Item 7.**Development Application: 8-24 Kippax St, Surry Hills - D/2023/1162****File No.:** D/2023/1162**Summary**

Date of Submission:	<p>The application was lodged on 9 January 2024.</p> <p>Amended architectural drawings and an amended Civil Engineering report were provided on 24 April 2024.</p>
Applicant/Owner:	Canva Pty Ltd.
Architect:	Cox Architects
Planning Consultant:	Ethos Urban
Cost of Works:	\$56,506,656
Zoning:	<p>The site is located within the MU1 Mixed Use Zone. The proposed development relates to the adaptive re-use of an existing building for commercial office uses, which is a permissible land use within the zone.</p>
Proposal Summary:	<p>The proposal involves the adaptive reuse of an existing 10 storey commercial building for ongoing office uses. The proponent is Canva, an online design and visual communications company. Canva are also the site owner.</p> <p>The proposal involves:</p> <ul style="list-style-type: none">• retention of the majority of existing building structure with insertion of new structural bracing, reinforcing of existing fabric and new fenestration;• demolition and re-construction of the lift and circulation core to the eastern edge of the buildin

Figure 15: Amendments made to the scheme, including repurposing of a pop-up retail space as a two vehicle loading dock (red arrow), and reduction of door widths at Sophia Street (blue arrows). Proposed flood gates and internal level changes to address flooding are clouded red.

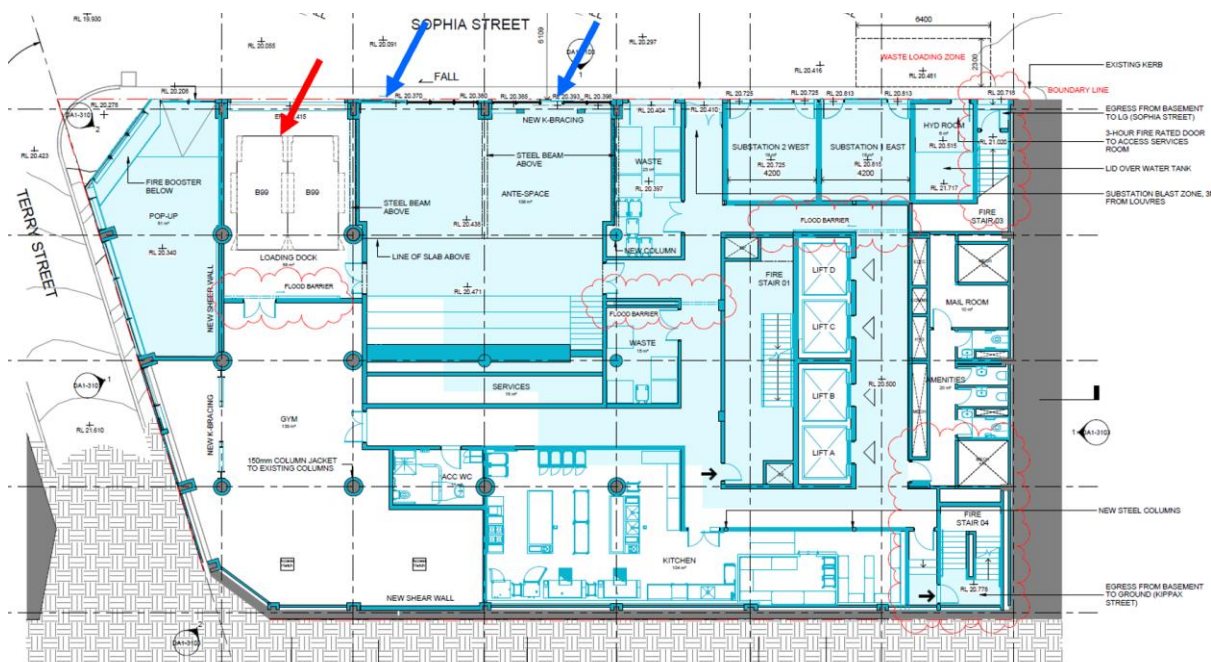
21. On 24 April 2024, amended architectural drawings were provided and an amended flood report was provided. The updated documents demonstrate that where finished floor levels do not satisfy recommended flood levels, that internal flood gates will be activated in the event of a flood (Figure 15 below). The flood gates will activate to recommended flood levels, with the intention of protecting the basement areas of the building.

Figure 34: Existing height of building, measured between Kippax and Sophia Streets (left). The building has a proposed maximum building height of 39.9m, measured from existing ground levels at the Sophia Street frontage (right).

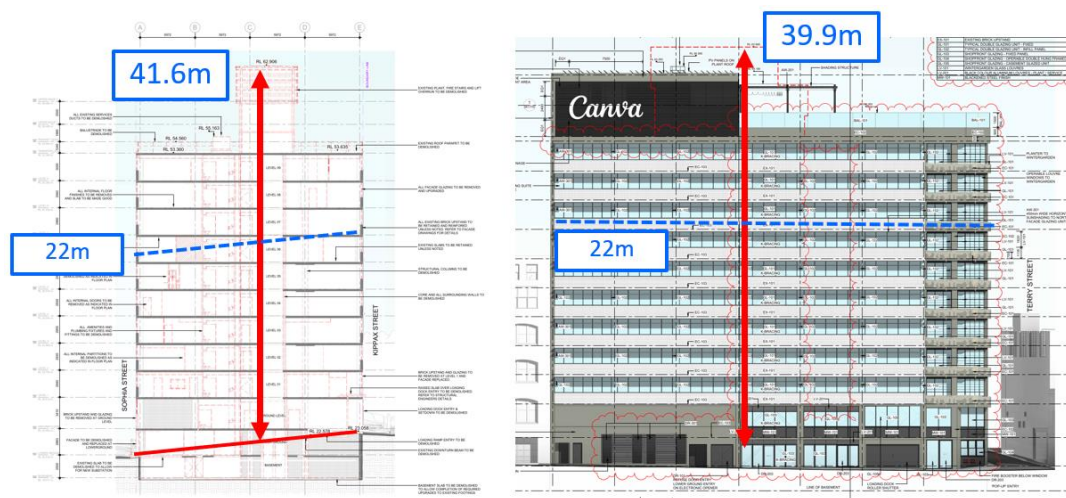
52. The site is subject to a maximum height of buildings development standard of 22m. The existing building has a height of approximately 41.6m and exceeds the 22m development standard by 19.6m (89%).
53. The proposed development includes the removal of the centrally located roof plant and the construction of new structure at the roof level containing plant and amenities. The new structure proposes a new maximum height of building of 39.9m, as measured at the Sophia Street boundary.
54. The proposal exceeds the 22m height of buildings development standard by a maximum of 17.9m (81%), which is a reduction in building height of approximately 1.7m as compared to the existing condition of the site.

Figure 36: original plans lodged with the application show the Town Hall ante-space was to be provided with full width doors opening onto Sophia Street with a combined width of 8m.

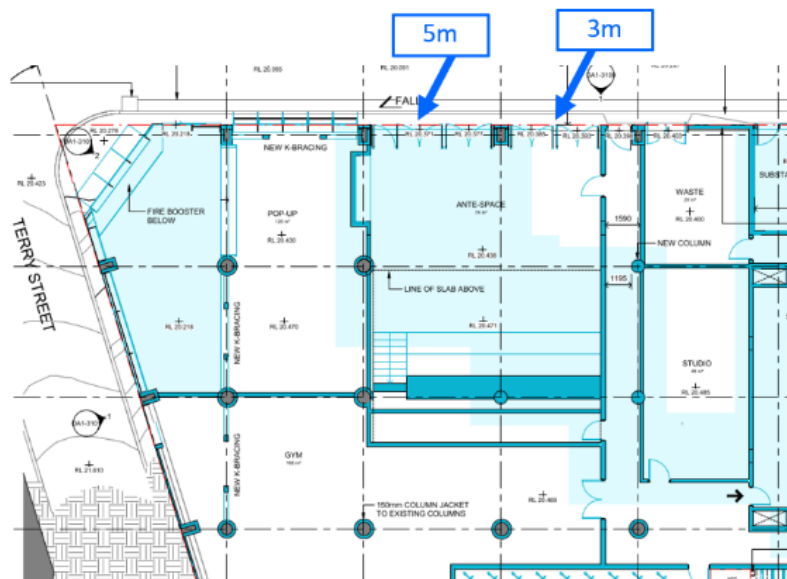
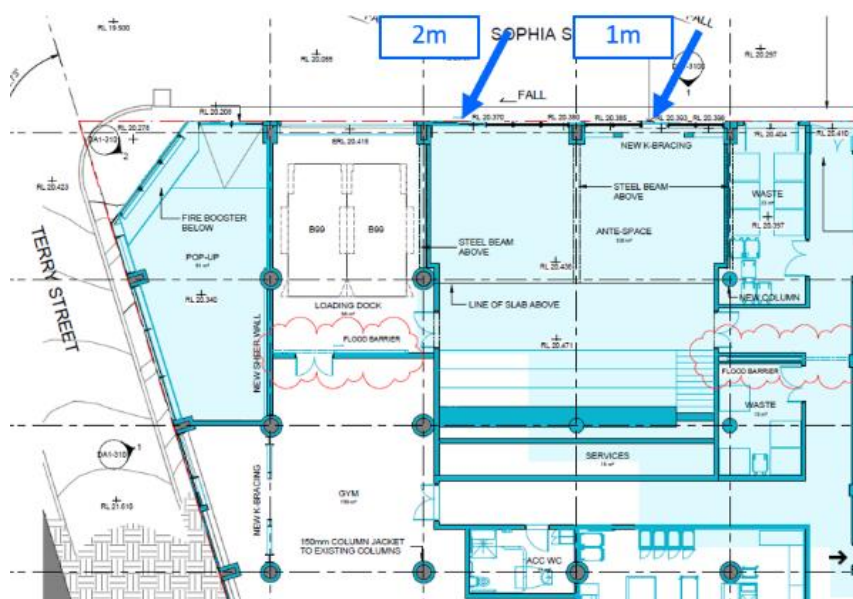
73. Amended ground level drawings demonstrate doors for the 'Town Hall' ante-space at the Sophia Street frontage have been substantially reduced in width. Originally, full width doors provided for the footway of Sophia Street to function as a 'break out space' for occupants of the building (Figures 36 and 37 below).
74. The use of Sophia Street itself as a break out space was not supported by Council's planners on the grounds of poor pedestrian safety, amongst other things. Vehicles turning left from Terry Street into Sophia Street have a limited line of sight and would not generally expect pedestrians to be on the roadway within a service lane.

75. Notwithstanding the redesign of the doors, a condition is recommended that the roadway of Sophia Street is not suitable for events associated with the site. A condition is also recommended requiring the preparation of a plan of management relating to the use of the Town Hall ante-space.
76. The management plan is required to address recommendations made by the amended acoustic report, including that doors and windows to Sophia Street must be kept closed at specified times to achieve required noise criteria. The intentions of requiring a management plan are to maximise pedestrian safety and to ensure the function of the Town Hall area will not have any significant impacts for the residential amenity of neighbouring buildings.

Figure 37: amended drawings show doors opening onto Sophia Street have been reduced to narrower apertures with a combined width of 3m.

Figure 39: proposed illuminated top of building 'Canva' sign, facing north towards the Sophia Street boundary (day and night).

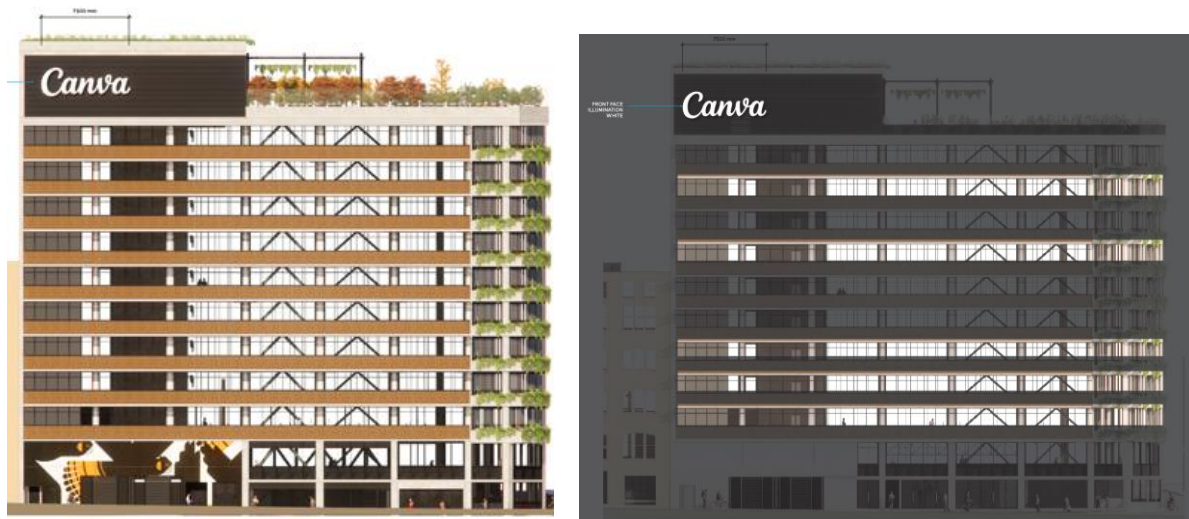
84. Section 3.16.5.2 of SDCP2012 specifies that outside of the SP5 Metropolitan Centre zone and the E2 Commercial Centre zone, top of building signs building identification sign should not be installed higher than 15m above the existing ground level or the top of any existing parapet (whichever is lower). The proposal involves installing a top of building sign to a height of approximately 36m (Figure 39 below).

85. The proposed sign is supported on the basis it is to be installed on a new element located at the top of an existing building. The sign will not be readily visible from surrounding side streets and will not comprise an element of visual clutter. The sign will be visible only from some distance from the site, including from the Central Station precinct.
86. The sign is similar in relation to building height to an existing sign within close proximity to the site at 72-84 Foveaux Street (Figure 41 below) and similar to existing signs on taller buildings outside of the Central Sydney area, associated with student housing within the Eveleigh and Sydney University Precincts (Figure 42).

89. The provisions require that consent for top of building signs is to be limited to 5 years. However, this requirement is considered unnecessary in the circumstances given Canva is the property owner. Instead, a condition is recommended that the top of building sign must be removed in the event that Canva vacate the building.

Figure 47: Section drawings showing projecting planter boxes (Kippax Street and Terry Street).

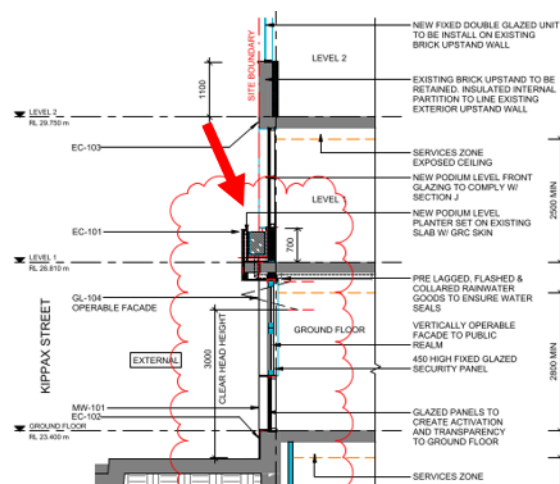
103. The level 1 planter boxes are proposed to extend over the property boundaries of Terry and Kippax Streets by approximately 450mm and are elevated above the footpath level by a minimum of 3.7m.

112. The planters have soil depths of 700mm and widths of 450mm, meeting recommended soil depths in the City's Landscape Design Code. A condition is recommended requiring the preparation of a Facade Maintenance Strategy, prior to the issue of a construction certificate.

113. A condition is recommended that a Positive Covenant must be registered on the title of the subject lot, requiring the lot owner to maintain all projecting planters in perpetuity. The Positive Covenant must indemnify Council against any claims and damages, will indemnify Council and provide for the maintenance, upkeep, and repair of the planter boxes.
